AIA Document G731™ – 2019

Change Order, Construction Manager as Adviser Edition

PROJECT: <i>(name and address)</i> Central Hardin High School Addn/Renov Cecilia, KY OWNER: <i>(name and address)</i> Hardin County Board of Education 65 W A Jenkins Road Elizabethtown, KY 42701	CONTRACT INFORMATION: Contract For: BP 030-07 General Trades Date: July 14, 2021 ARCHITECT: <i>(name and address)</i> JRA Architects 3225 Summit Square Place, Suite 200 Lexington, KY 40509	CHANGE ORDER INFORMATION: Change Order Number: 086 Date: November 8, 2023 CONSTRUCTION MANAGER: <i>(name and address)</i> Alliance Corporation 116 E. College Street Glasgow, KY 42141
CONTRACTOR: <i>(name and address)</i> Alliance Corporatoin P. O. Box 1480 Glasgow, KY 42142-1480

Costs associated with obtaining engineering judgement for fire resistant rated wall to wall joints and expansion joints at Area A lobby windows.

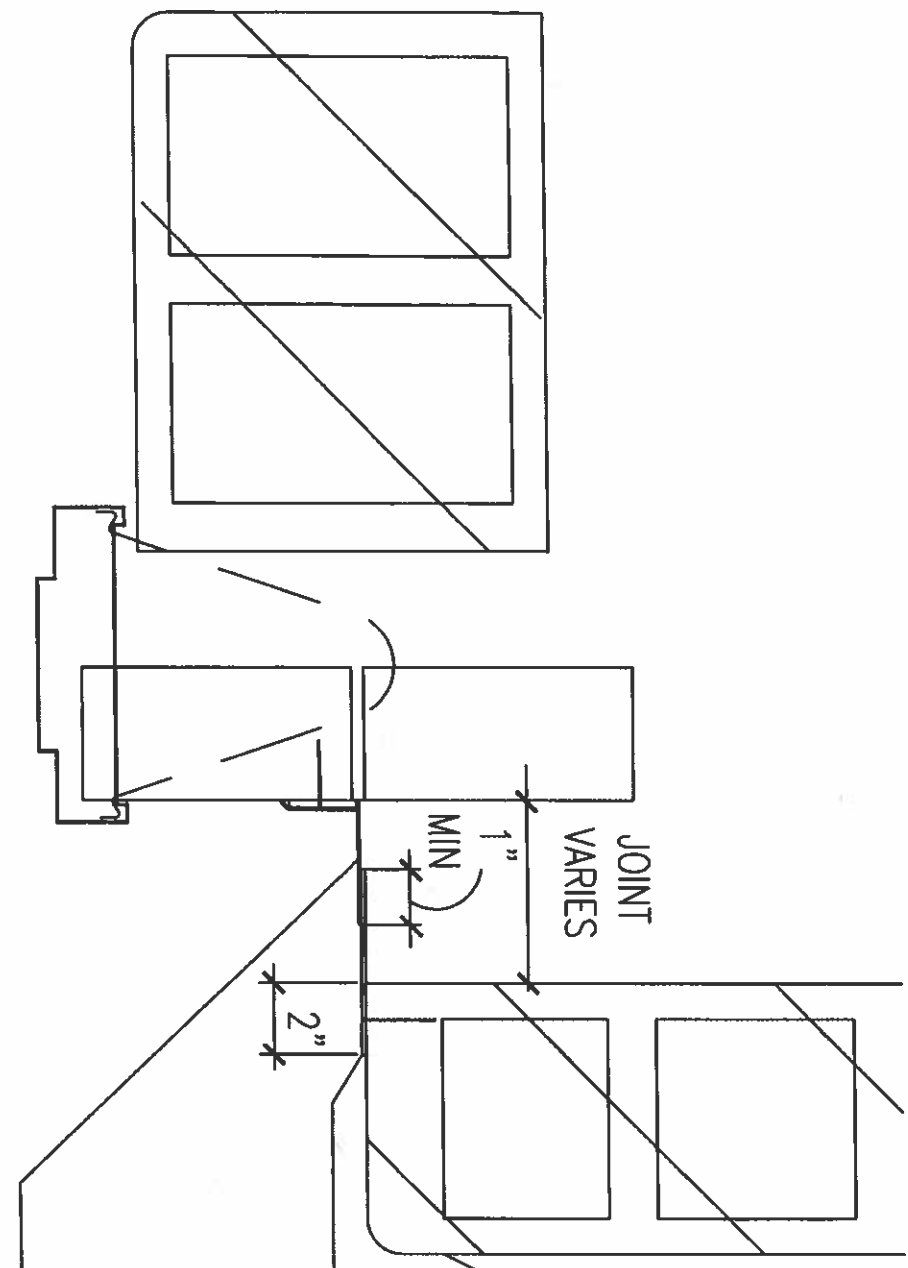
The door and window openings (See PR for added windows and expansion joints) into the gym on the Sub Level Area A must have expansion joints that have fire resistant rating. To achieve this, the fire-resistant joint system must be added to the expansion joints already shown at the heads, jambs and sills of the windows and doors.

The contractor and supplier need to review the fire-resistant rated joint at the water stop detail on the platform (Detail E-A-312) to ensure that the variations in the width of the joint caused by the irregular conditions between the gym wall and the water stop can be met with the fire resistant rated joint material. Obtain an engineering judgement if necessary.

A fire-resistant rated wall to wall joint must be added in the 2" wide expansion joint between Area A and Area B from the First Level up to the water stop detail on the mechanical platform. Since this is concealed in the double wall construction, no expansion joint cover is required.

ALUM EXP JNT REV

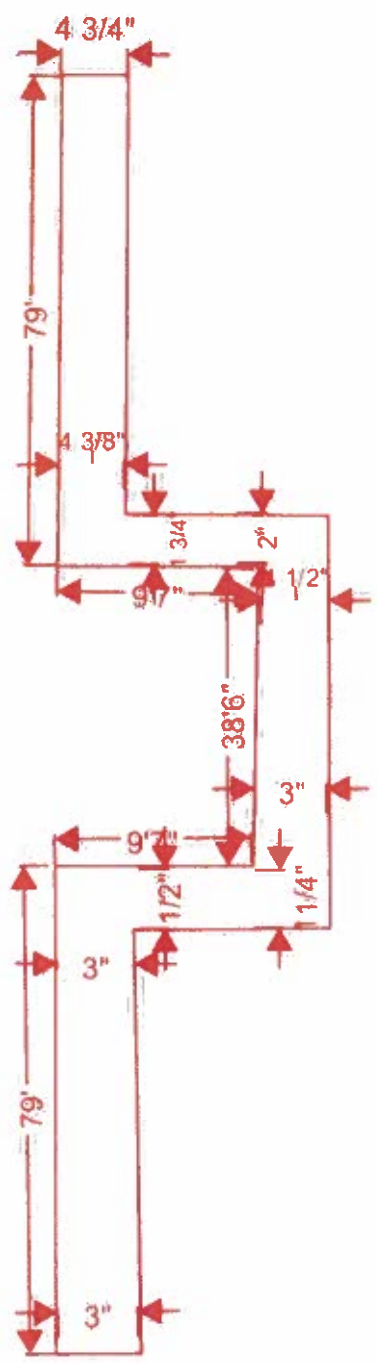
JOINT
VARIES

5" WIDE ALUM PL
VERIFY WIDTH
SECURE TO CMU W/
SS CNTSK SCREWS INTO
PLASTIC EXP ANCHORS
@ 2'-0" O.C.

ALUM EXP JNT

Drawing No.
600372a

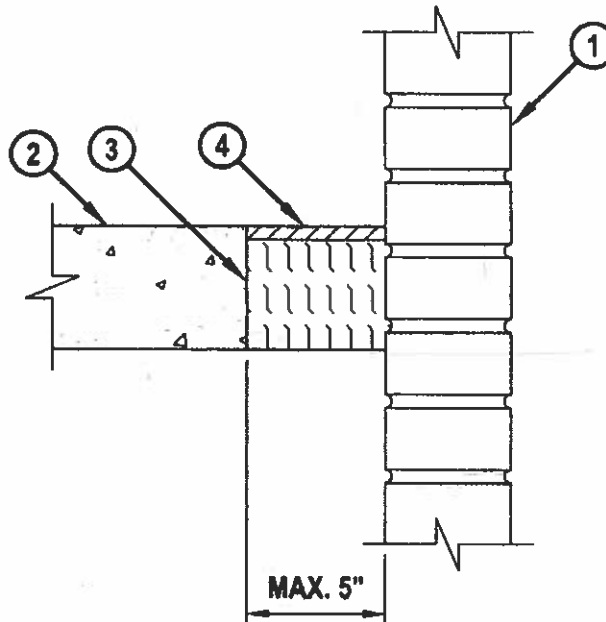
ENGINEERING JUDGMENT FIRESTOP DETAIL

CROSS-SECTIONAL VIEW

1. CONCRETE WALL ASSEMBLY TO BE ONE OF THE FOLLOWING (2-HR. FIRE-RATING) :
 - A. LIGHTWEIGHT OR NORMAL WEIGHT CONCRETE WALL (MINIMUM 4-1/2" THICK).
 - B. ANY UL/cUL CLASSIFIED CONCRETE BLOCK WALL (MIN. 4-1/2" THICK) (SOLID OR GROUT FILLED).
 - C. LIGHTWEIGHT OR NORMAL WEIGHT BRICK WALL (MIN. 4-1/2" THICK) (SOLID OR GROUT FILLED).
2. LIGHTWEIGHT OR NORMAL WEIGHT CONCRETE FLOOR (MINIMUM 4-1/2" THICK) (2-HR. FIRE-RATING).
3. MINIMUM 4" THICKNESS MINERAL WOOL SAFING (MIN. 4 PCF DENSITY) COMPRESSED 50%.
4. MINIMUM 1/2" DEPTH HILTI CFS-S SIL GG FIRESTOP SILICONE SEALANT OR HILTI CFS-S SIL SL FIRESTOP SILICONE SEALANT.

NOTES : 1. MAXIMUM WIDTH OF JOINT = 5".
 2. T-RATING MAY NOT EQUAL F-RATING IN ACCORDANCE WITH APPLICABLE TEST METHOD.

Drawing No.
600405a

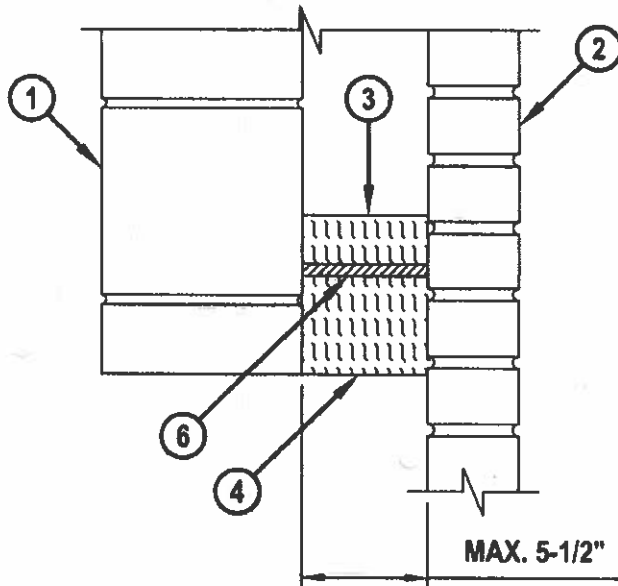
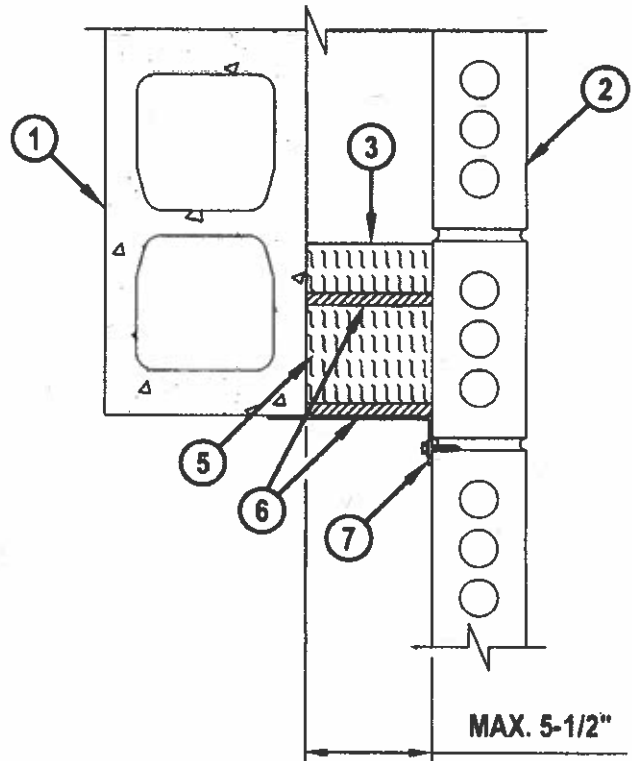
ENGINEERING JUDGMENT FIRESTOP DETAIL

CONFIGURATION A (CROSS-SECTIONAL VIEW)

CONFIGURATION B (TOP VIEW)

F-RATING = 2-HR. (SEE NOTE NO. 2 BELOW)
